AGENDA
SPECIAL ARCHITECTURAL REVIEW BOARD MEETING
Public Meeting Room, Village Hall
Monday, November 3, 2014
7:00 p.m.

3.1 CONTINUED Consideration and Discussion of a Site Plan, Landscape Plan, Building Elevations, Materials and Colors, and site lighting for a proposed four-level parking structure at 25/75 Tri-State International Office Center (Trammell Crow Company/Principal Real Estate Investors).

Subject:	Tri-State International Office Center – Parking Deck
Action Requested:	Review of Site Plan, Landscape Plan, Building Elevations, Materials & Colors, and Site Lighting for a proposed four-level parking structure at 25/75 Tri-State International Office Center
Petitioner:	Trammell Crow Company/Principal Real Estate Investors
Originated By/Contact:	Steve McNellis, Director Department of Community & Economic Development
Advisory Board Review:	Architectural Review Board

PROPOSED SITE PLAN

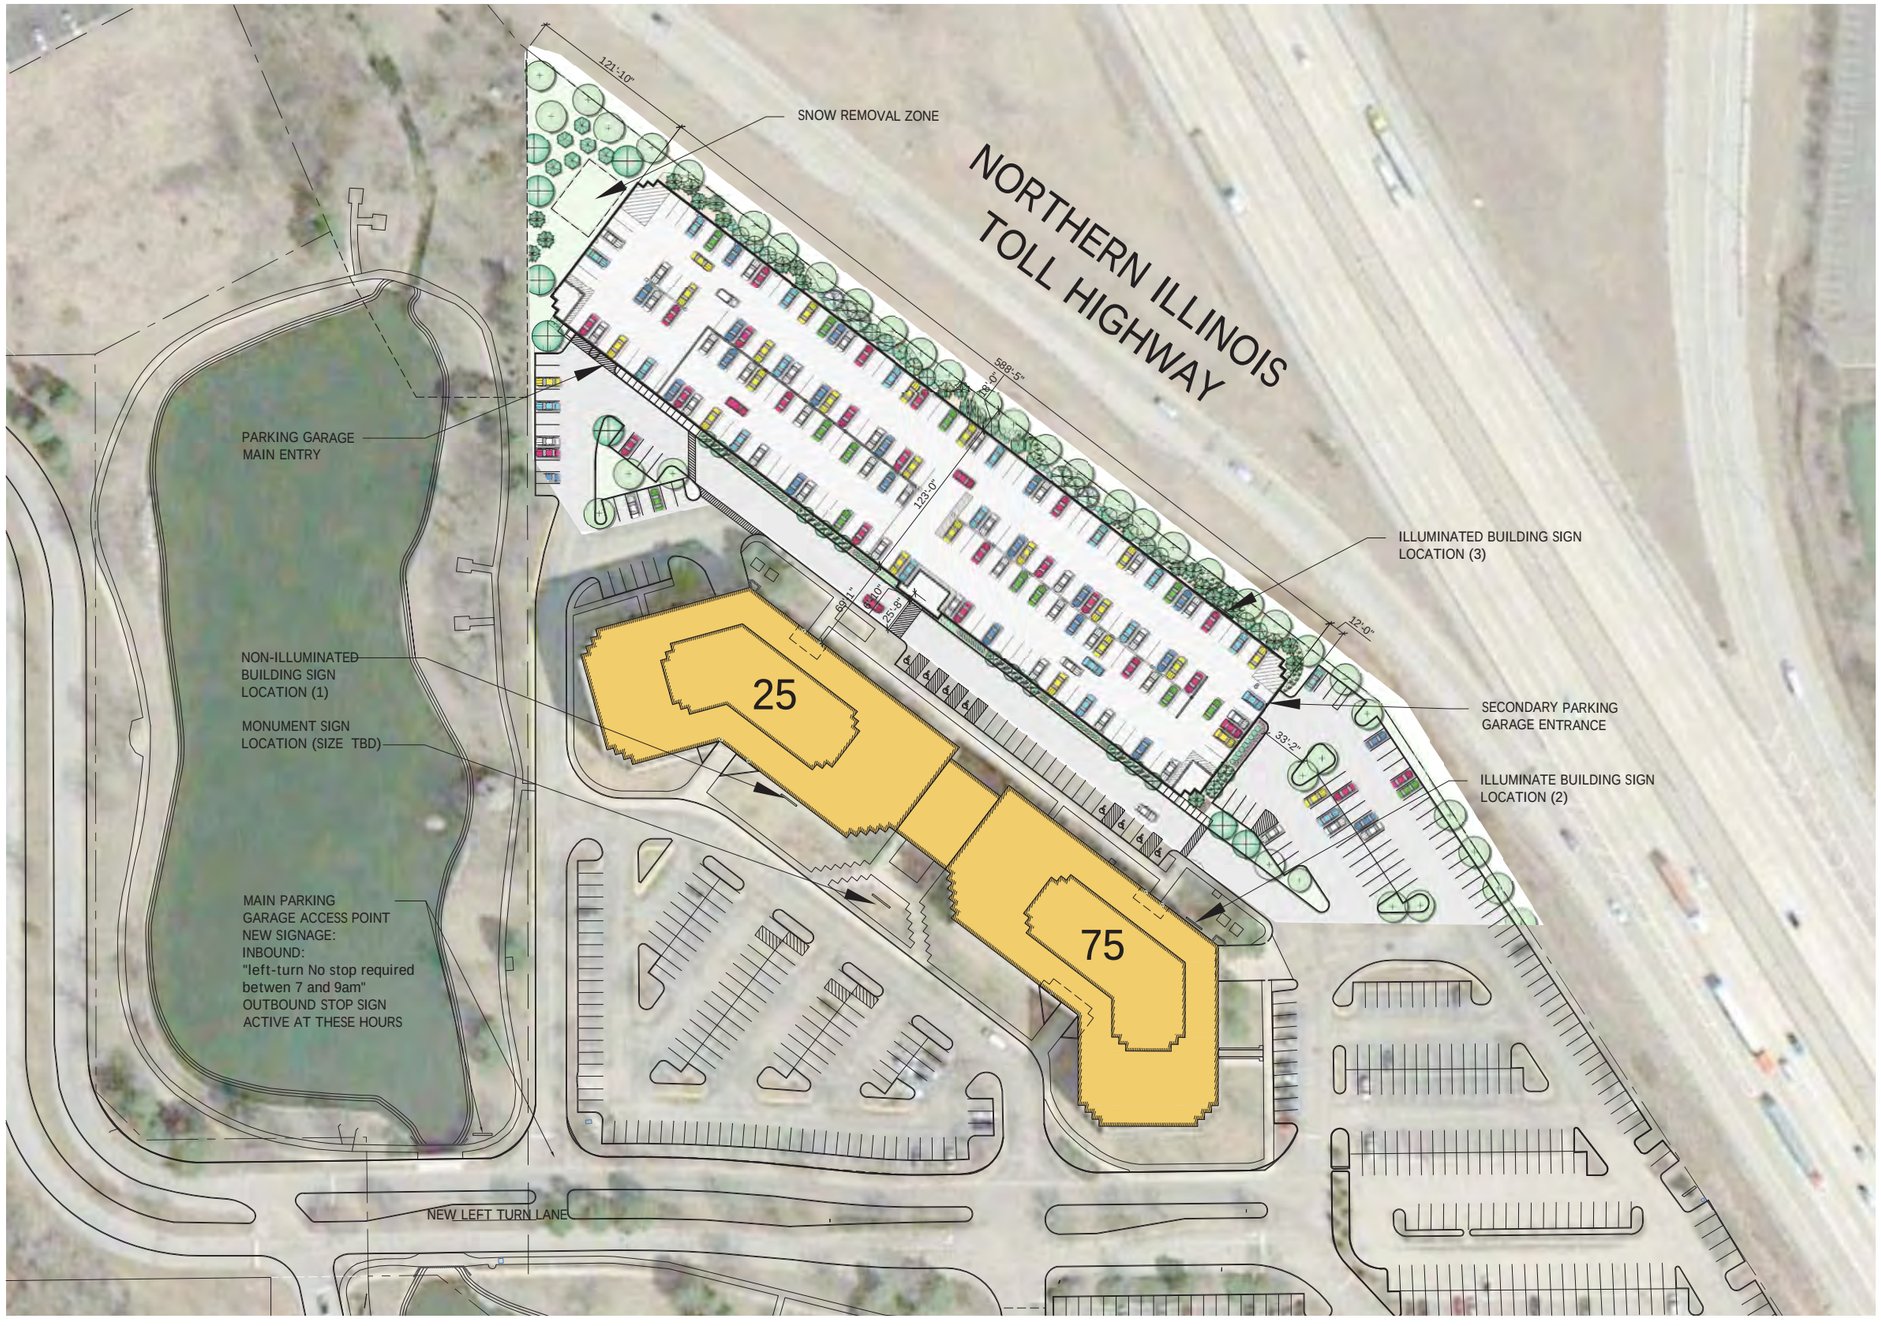
Project Architect Heerema discussed ingress and egress to the deck. **Chairman Pro Tem Hardnock** inquired about the safety of the northernmost stairwell that exits right at the main vehicular entrance to the deck. Project Architect Heerema stated they believe the majority of garage-users will gravitate toward the center elevator and stairwell structure. **Mr. Hamilton** stated as far as safety at the north stairtower they would consider a painted crosswalk at the north vehicular ingress to the deck. He further noted they ultimately want to get people out of the deck, across the parking lot to the closest building entry. Further, he believes people will form patterns as to their entrance to the building. Finally, he noted they would consider adding a clearance guide, showing maximum permissible vehicle height entering the deck, as it also would act as a good traffic calming measure. **Chairman Pro Tem Hardnock** stated he was just raising awareness of the issue because the proposal for a No-Stop left turn lane on the main entry road will help speed cars up to get them in the deck, so this could be a hot spot.

- The Petitioner has agreed to provide the "Clearance Bar" discussed at the last meeting as a safety-enhancement to slow traffic at the north vehicular entry to the parking deck.

- The pedestrian crossing from the south stairtower has been revised so that the sidewalk from the deck extends south for approximately 30', to a crosswalk that connects with an existing sidewalk, rather than the previous proposal in which the crosswalk connected to a handicapped-accessible parking space.

Landscape Plan

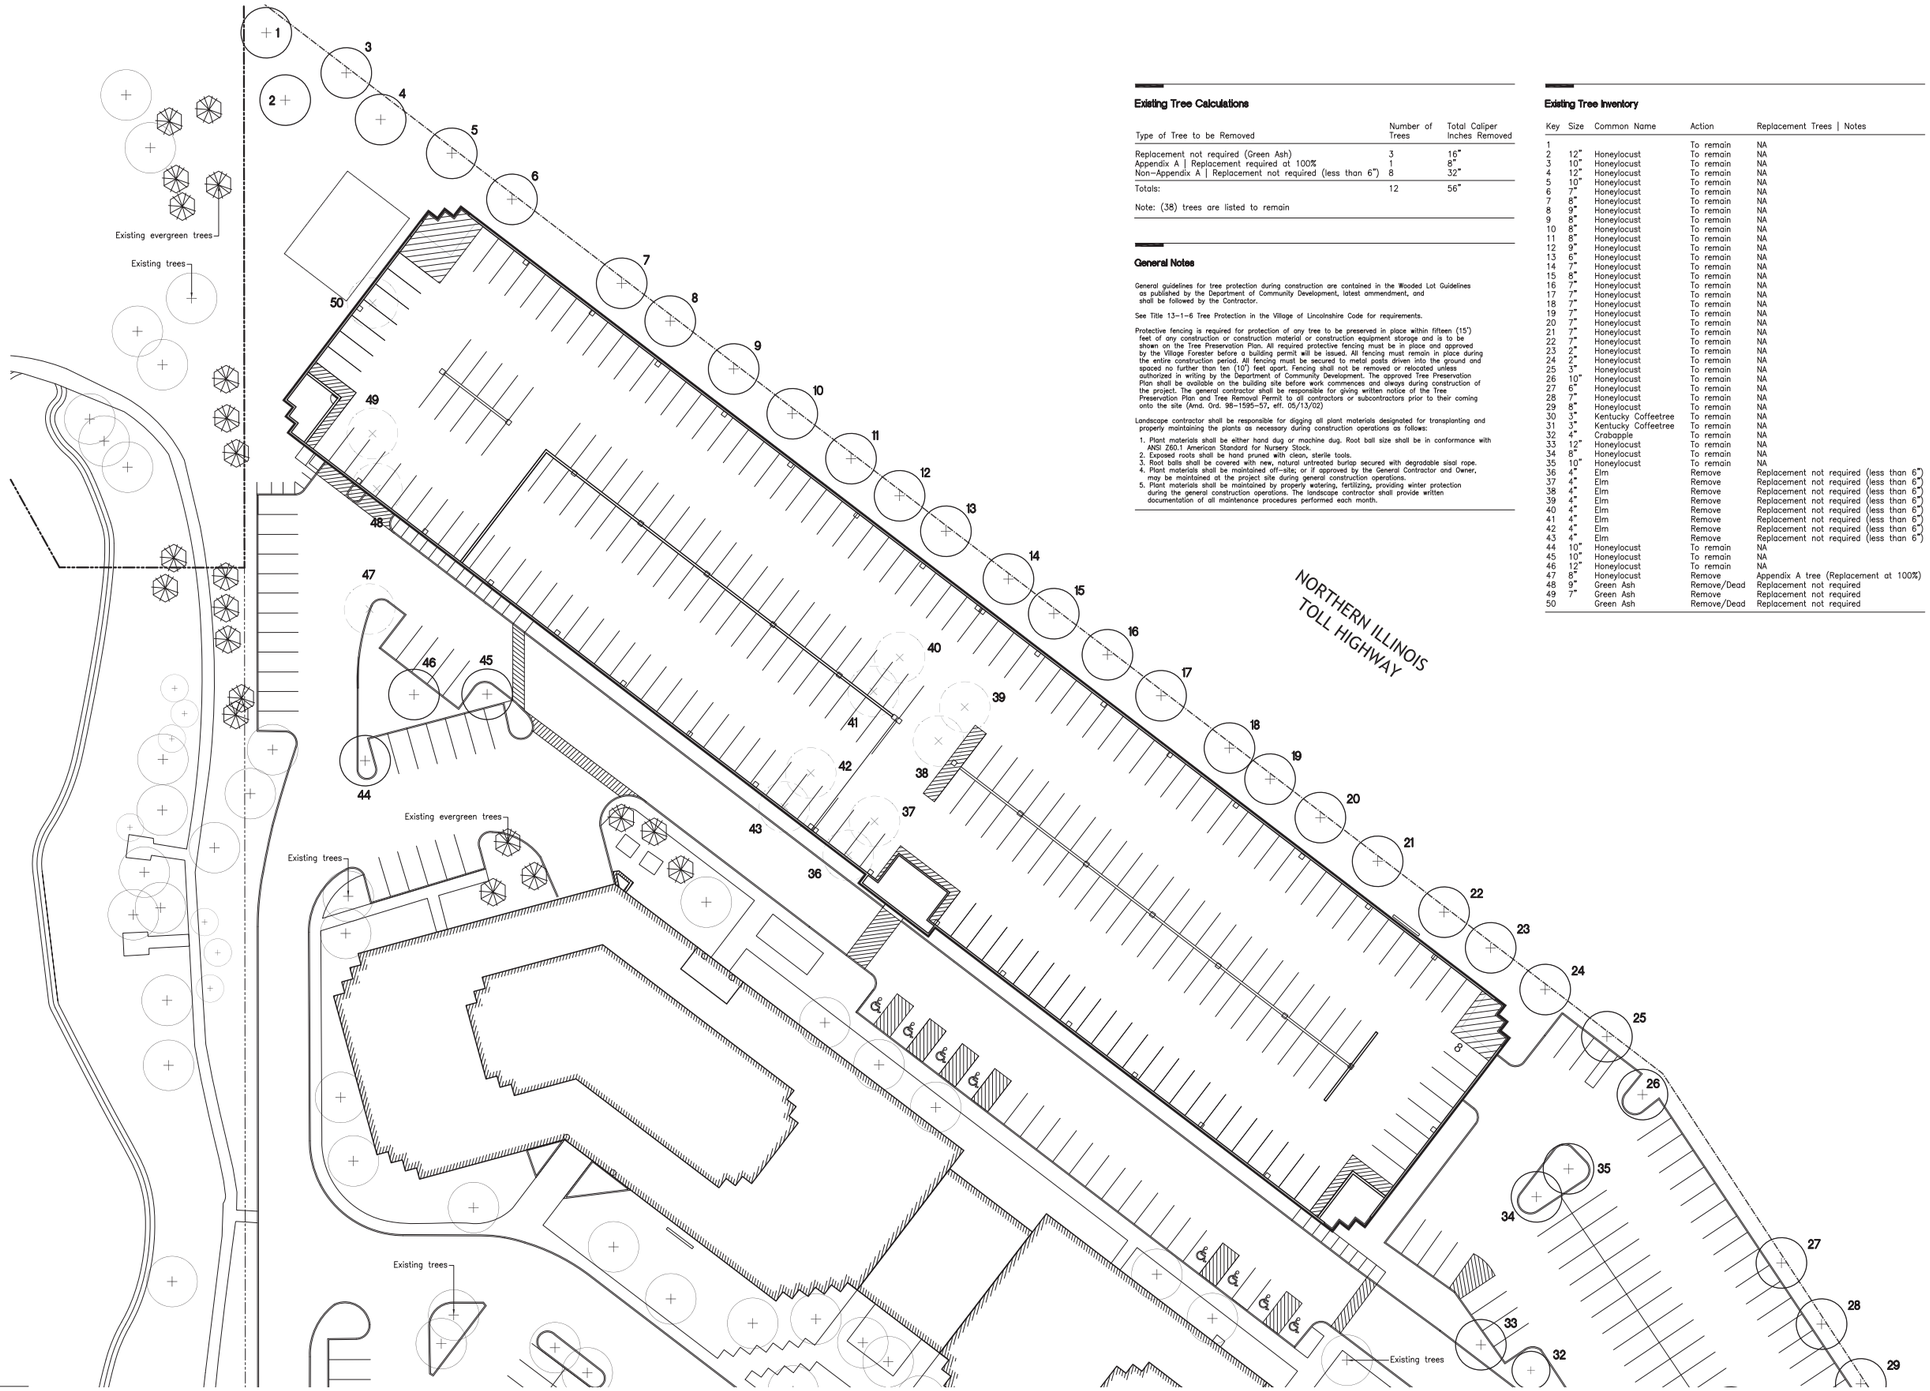
Member Kennerley asked what kind of low growing bushes are proposed, to which Landscape Architect McCallum stated they would be sumac and forsythia. **Member Kennerley** noted they lose their leaves, correct? She further noted it is important to have some evergreen bushes to maintain year-round greenery. She asked if Junipers or something similar could be added to provide that intermittent evergreen. **Landscape Architect McCallum** stated he hasn't found Junipers to be very salt-tolerant. However, he noted there are evergreen groundcovers that get a maximum height of 6-8". **Member Kennerley** requested that groundcover be mixed-in, perhaps around building entries, where it would be prominent.

Chairman Pro Tem Hardnock asked why Staff wanted low plantings at the base of the deck. **Director McNellis** noted the overall design has horizontal architectural elements that help screen, so Staff believes it is important to get these low plantings at the base to help screen and break up the longest part of the elevation, as well as ground the building.

- **Staff-Recommended Revision** – Provide additional understory shrubs, with mature heights of 4-8' along the Tollway on-ramp elevation of the parking deck to provide a "landscape base" to the building, and help screen the first level of vehicles.

- Over 80 Junipers have been either added or replaced deciduous plantings along the Tollway on-ramp elevation, to maintain year-round interest. These shrubs are primarily of a species that will grow to a height of 4-5' tall at maturity, so the previous Staff request for 4-8' tall shrubs is satisfied with this addition.

- Wintercreeper (evergreen groundcover) has been added at the major pedestrian parking lot entry (located at the middle of the deck) and adjacent to the north stairwell/north vehicular parking lot entry.

Site Sections

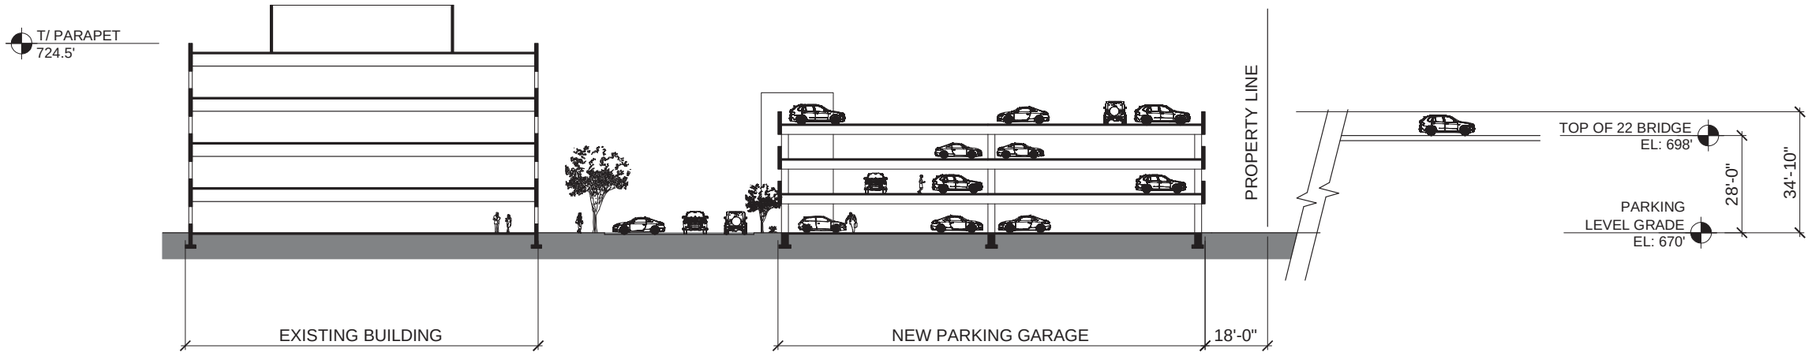
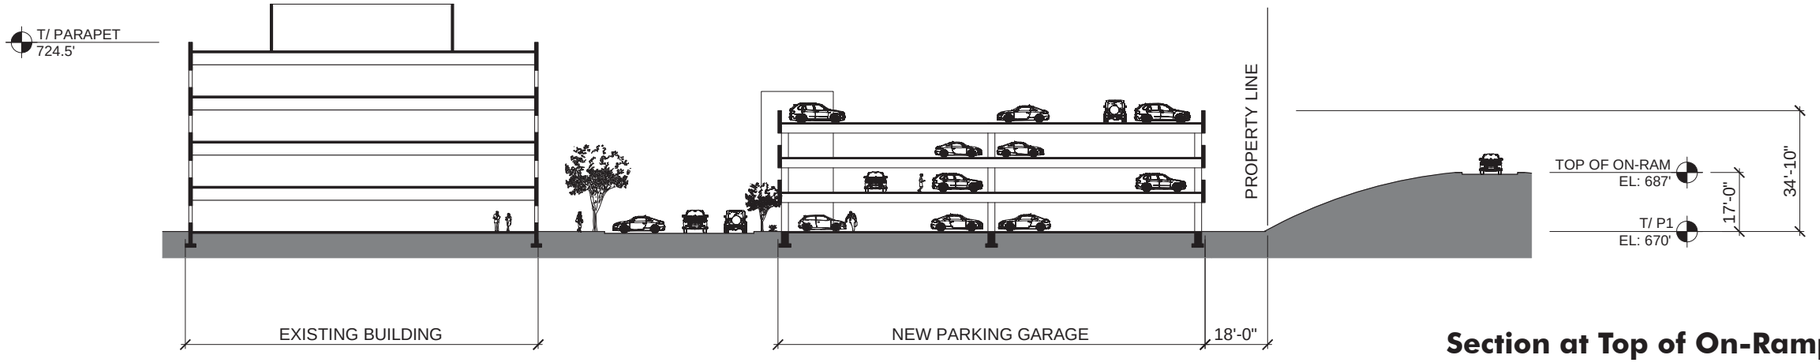
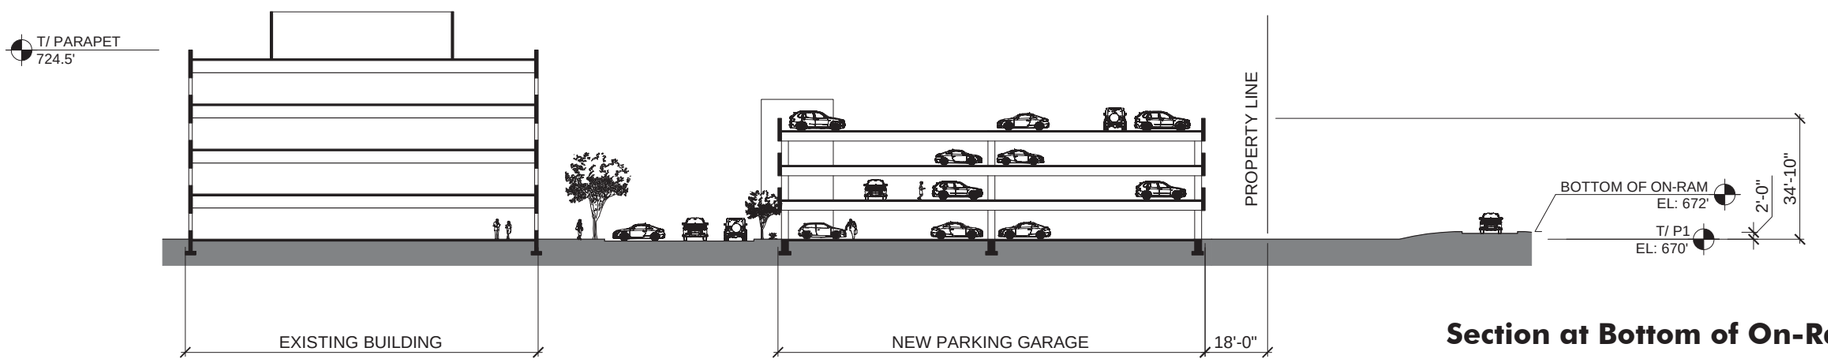
Project Architect Heerema continued reviewing the sections and exhibit demonstrating the relationship of the height of the adjacent tollway on-ramp to the parking deck height. **Member Schlect** asked if the section illustrates the actual distance of the on-ramp from the deck? **Project Architect Heerema** stated it was intended to represent that, but doesn't appear to show the proper distance.

- Fin colors are now shown as either blue or black. The petitioner is requesting approval of both colors, to allow the prospective tenant flexibility.
- Site Sections have been revised to accurately show the distance between the parking deck and the Tollway ramp.

Painted Aluminum Fins

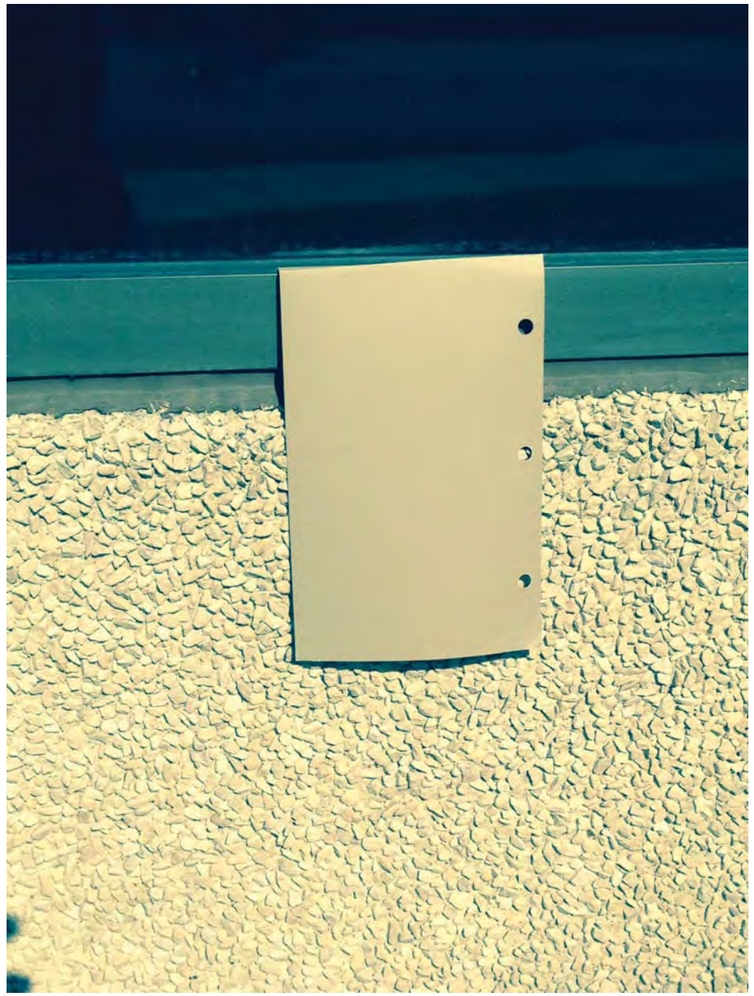
Member Kennerley stated since we went through a signage package that was approved for a blue color theme, why would the petitioner consider red fins as an option? She noted her position that they should stick with the blue fins and the blue theme. **Mr. Hamilton** said they suggested the red and blue alternatives so they could offer the tenant a color to match their branding schemes. Member Kennerley asked the color of the tenants logo. Mr. Hamilton stated it would likely be red, but the fins could also possibly be unpainted if that was [preferred by the ARB.

Member Kennerley noted if they do fins, its important they block wind. If the color of the fins is not to be blue, it should be black. Non-colored steel doesn't work with the color palette. **Mr. Hamilton** stated the color wasn't so much driven by the tenant than it was Trammell Crow trying to create an effect. **Member Kennerley** stated blue is the better option, as it matches the signage. **Mr. Hamilton** noted they'd be comfortable with blue or black. **Chairman Pro Tem Hardnock** noted he's not opposed to the red on the rendering, but blue or black are ok. **Member Gulatee** stated the building and siting are more important than fin colors. He noted he sent a memo to everyone echoing this point on siting.
